Dominion – Warren County Power Station

Prevention of Significant Deterioration Permit

DEQ Response to Comments Document

December 7, 2010

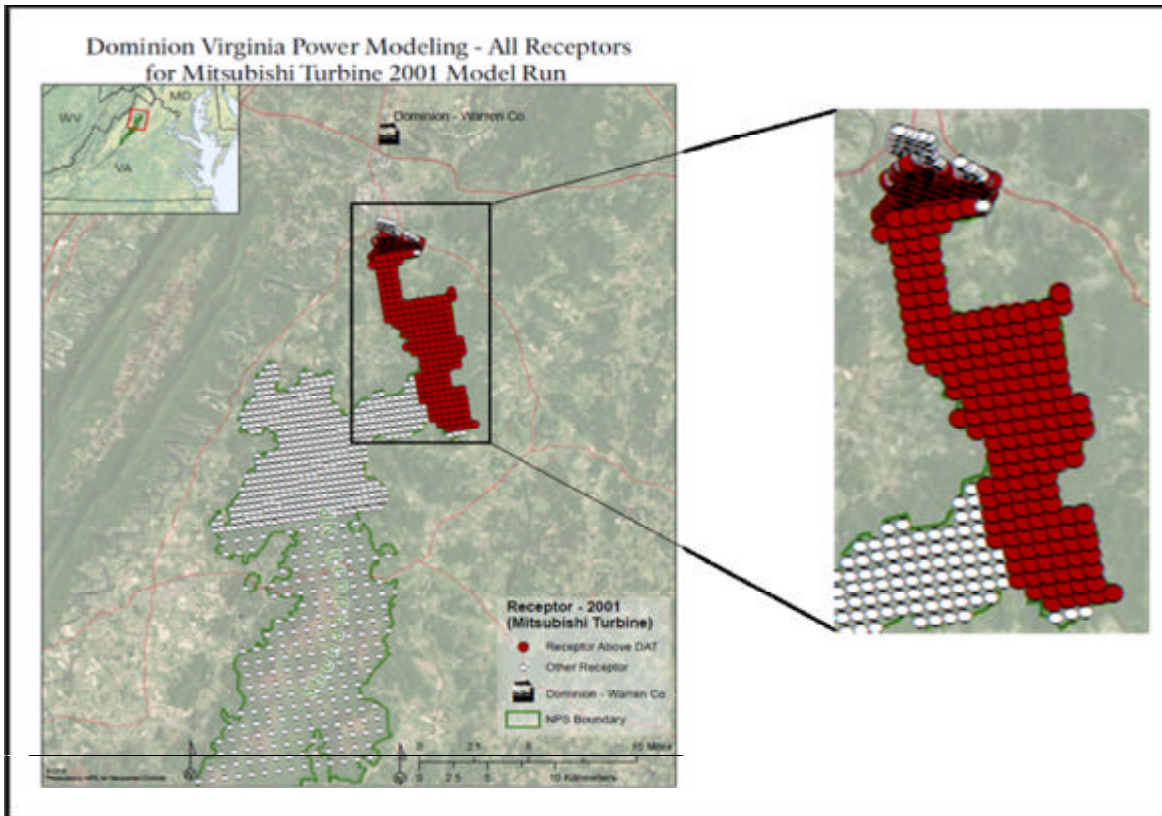
Respondents also reiterated that the modeling of the proposed facility demonstrated nitrogen acid deposition impacts to already impaired streams in the northern watersheds within the SNP.

Recently collected stream samples, although not certified by DEQ, indicate that stream acidification in the SNP continues to impact water quality. For example, the Shenandoah Watershed Study (SWAS) program conducts watershed research and monitoring in the Shenandoah National Park as well as other areas. The SWAS program studies acidic deposition in sensitive streams, most of which support reproducing populations of the native brook trout. The SWAS program concluded that stream water acidification is a continuing problem in Virginia's forested mountain watersheds. A link to the SWAS program is provided below:

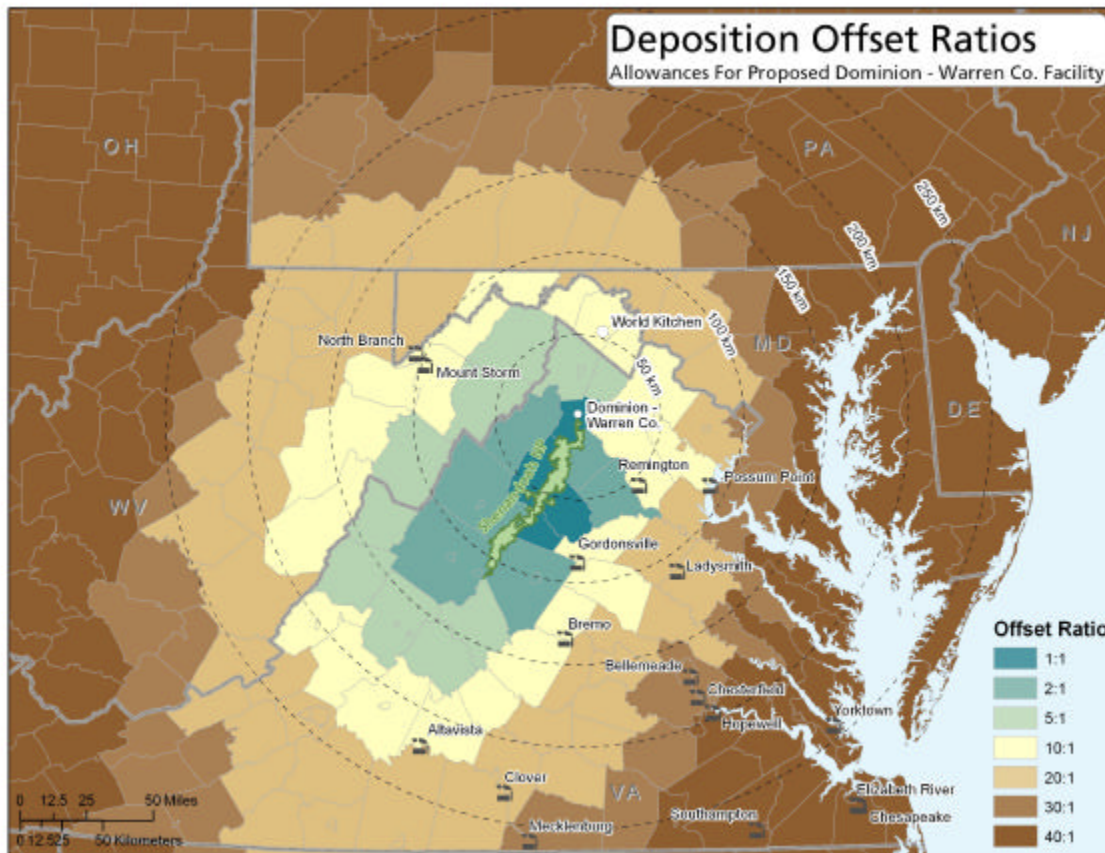
Respondents desired to strengthen the draft mitigation plan ratios from 1.15:1 to 2:1 for sources close to the SNP and 3:1 if the facilities are farther away.

Respondents suggested that the offset ratios be strengthened in the draft permit by obtaining nitrogen oxide offsets from other sources within close proximity to the SNP. Additionally, concerns have been raised as to whether the offset provisions in the draft permit are sufficient to mitigate the adverse impacts to AQRVs in the SNP.

Response: DEQ has strengthened the mitigation plan in the draft permit based on comments received from the NPS and the general public. The elements of the revised mitigation plan are as follows:

The map depicts much higher offset ratios than originally proposed in the draft permit.
